**WHITLEY COUNTY ADVISORY PLAN COMMISSION  
STAFF REPORT**

**20-W-SUBD-14 REPLAT**

Crooked Lake Estates, replat of part of Forest Park Addition, etc.

**AUGUST 19, 2020**

# CROOKED LAKE ESTATES (PRELIMINARY)

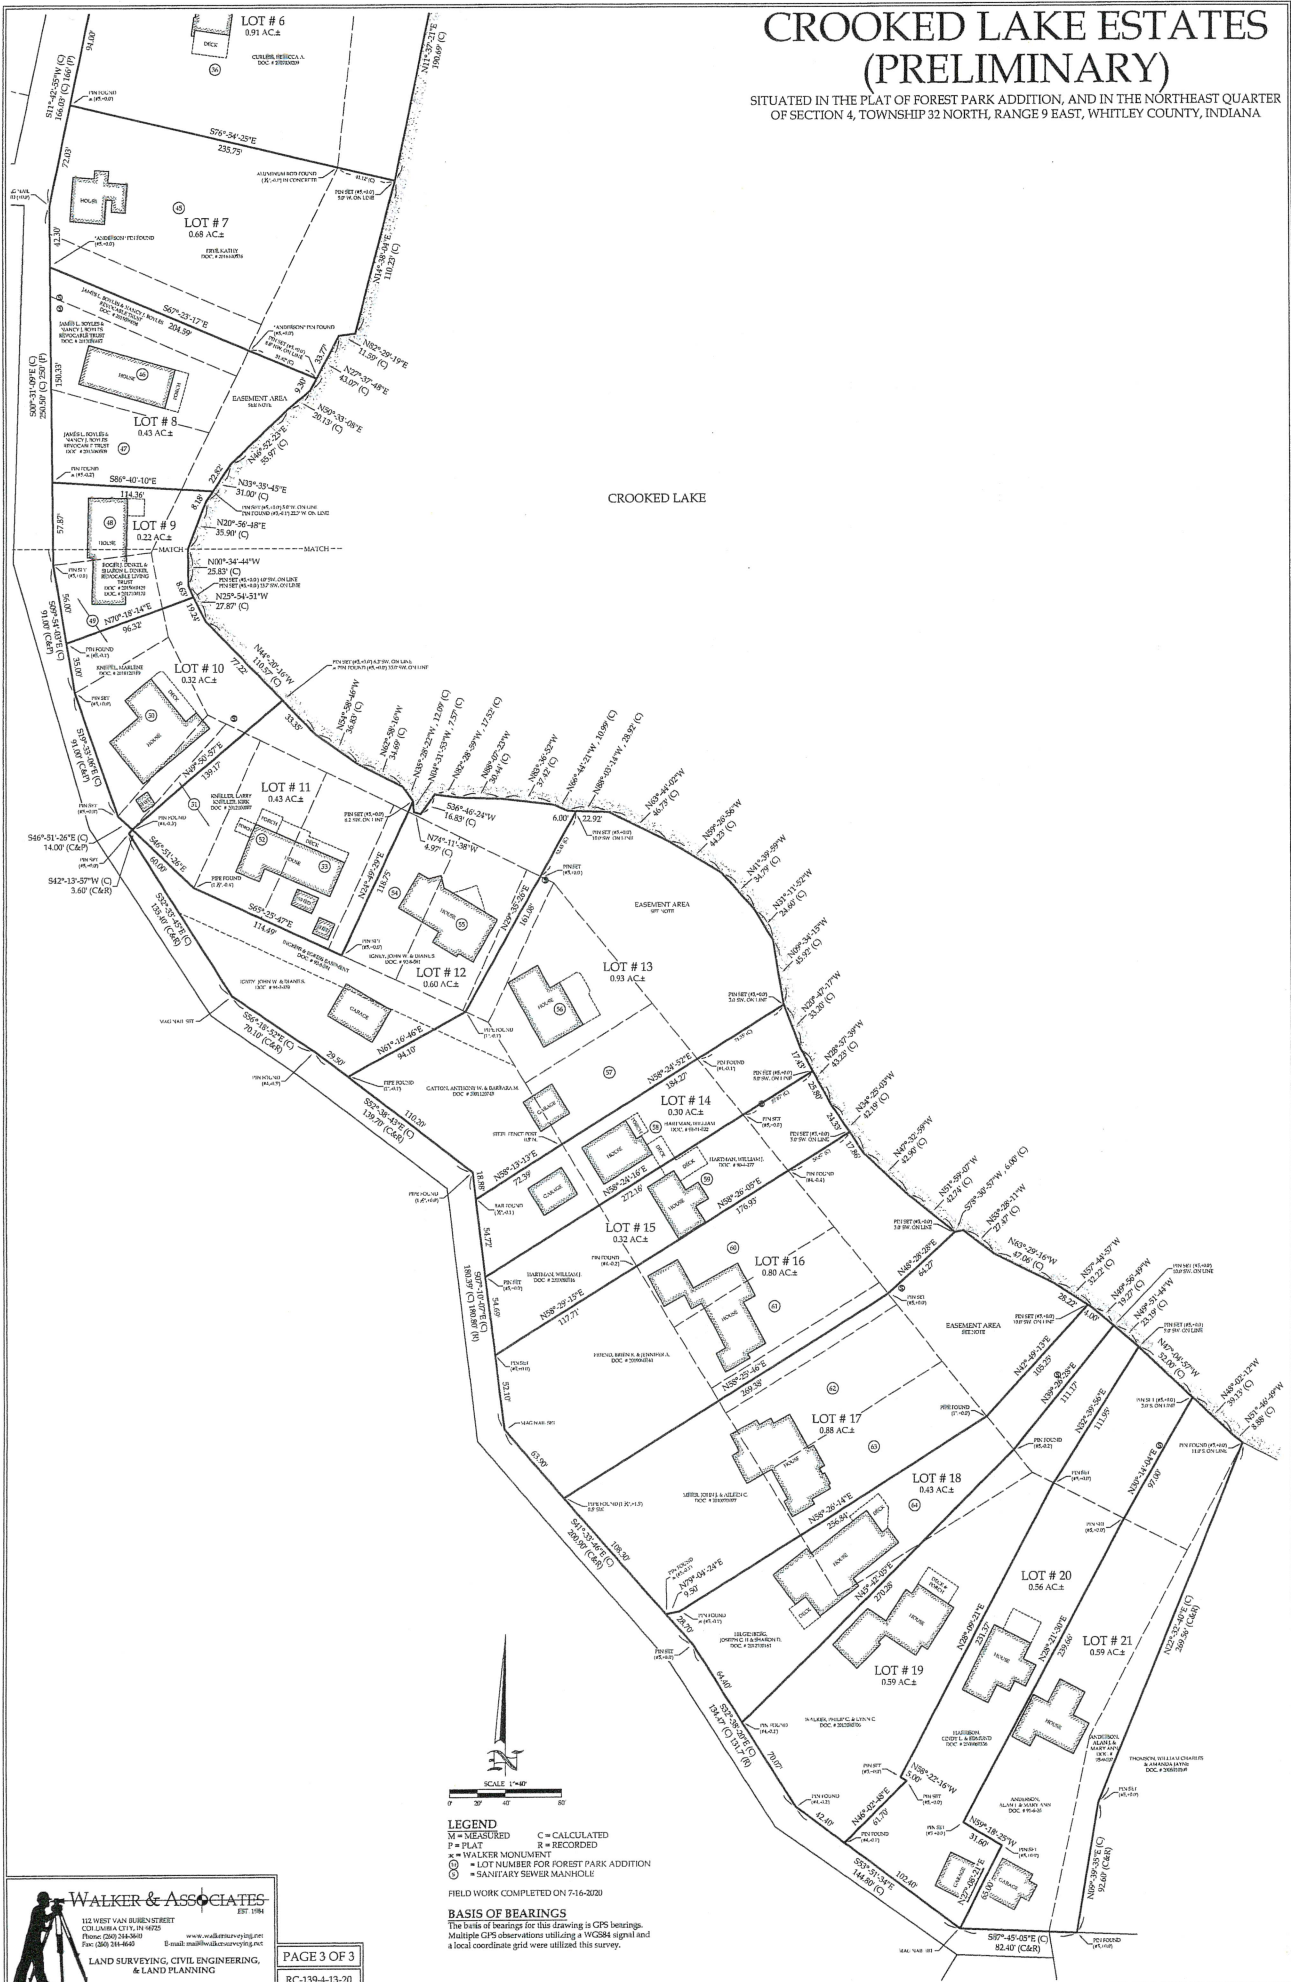
Being largely a replat of part of a subdivision platted in 1927, many aspects of the proposal incorporate existing legal nonconformities. As has been done with previous replats of aged subdivisions, while the proposed plat does not meet every current standard, it does not create new nonconformities with the zoning code and so variances are not required. That said, all but one of the proposed lots do meet the minimum lot area and frontage requirements, and about  $\frac{3}{4}$  of them meet the minimum lot width. The ingress/egress easement used to provide access to proposed Lot 11 does need to be shown on the plat.

While not providing a formal letter, the County Engineer expressed concern about the lack of road right-of-way being dedicated along Morsches Road, and to a lesser extent, Valley Avenue, as the R/Ws are narrower than the typical county road. The current width of the Morsches Road R/W is typically a nominal 20' in width, but at some points it narrows to 16'; for comparison, most alleys were platted at 16'-20' wide and most county road R/Ws are 40'-50'. Actual pavement width is 16', more than 10' narrower than the minimum pavement width required for new subdivision streets.

As noted in the comments from the Soil & Water Conservation District, drainage from adjacent properties to the west is also a concern, as platted "access strips" and lot lines over time have become used to convey drainage to the lake. Specifically, a drainage channel existing along the north side of the proposed Lot 7, and drainage flows roughly between the proposed Lots 11 and 12. Being a new plat, stormwater management is not something that can be simply treated as "legal nonconforming," and appropriate easements or infrastructure need to be included on the proposed plat.

The electric company stated that power lines exist on these lots, and those easements must be added to the plat where applicable. Similarly, the sanitary sewer easements need to be shown. In both instances, the petitioner has already indicated that they would research and add the easements to the plat prior to recordation. The Plan Commission may want to consider requiring utility easements on the plat where applicable to ensure future access.

The Parcel Committee members had comments regarding ownership and definition of the easement area. More specifically, the lakeshore area underlying the proposed Lots 19-21 is not currently in the tax records; title to that area must be cleared prior to recordation of this plat.

The easement area is noted on the plat and in the text, and it is assumed that the area aligns with the lakeshore area of the old subdivision plat (which is where the easement note text originates). However, no dimensions of the easement are shown to clearly indicate where the easement lies.

I have reviewed the plat for Crooked Lake Estate. While most easements are acceptable, we are requesting additional 20' Utility Easements along the existing Columbia City Electric Department infrastructure located on future lots 11-13 and Lots 17-21. Please reference the highlighted area on the attached map.

Aerial photos on Whitley GIS show an ephemeral drainage channel running along the north property line of Lot # 7 from a culvert crossing Morsches Road to the lake. The channel receives drainage from a small watershed of about 40 acres. It's possible that DNR and/or IDEM will consider waters flowing through the channel to be waters of the state.

Aerial photos on Whitley GIS suggest there may be a culvert crossing Morsches Road near the west end of the ingress/egress easement on Lot #12. A culvert at that location would receive drainage from a watershed of about 29 acres. I couldn't determine a flow path from that location to the lake, but I wonder if there is a pipe from the road to the notch in the lake shoreline at the northwest corner of Lot #12.

Both drainage pathways described above show in blue line on the USGS map for StreamStats. Are drainage easements needed on the plat?

1. Easements, dimensions, text, etc. must be shown on the secondary plat (with review by Parcel Committee prior to recordation) as discussed above.
2. Any required right-of-way be dedicated along the adjacent county road(s) per the County Engineer.
3. Drainage easements and/or infrastructure be included per requirements of the SWCD and County Engineer.
4. Secondary plat approval delegated to the Plan Commission Staff.
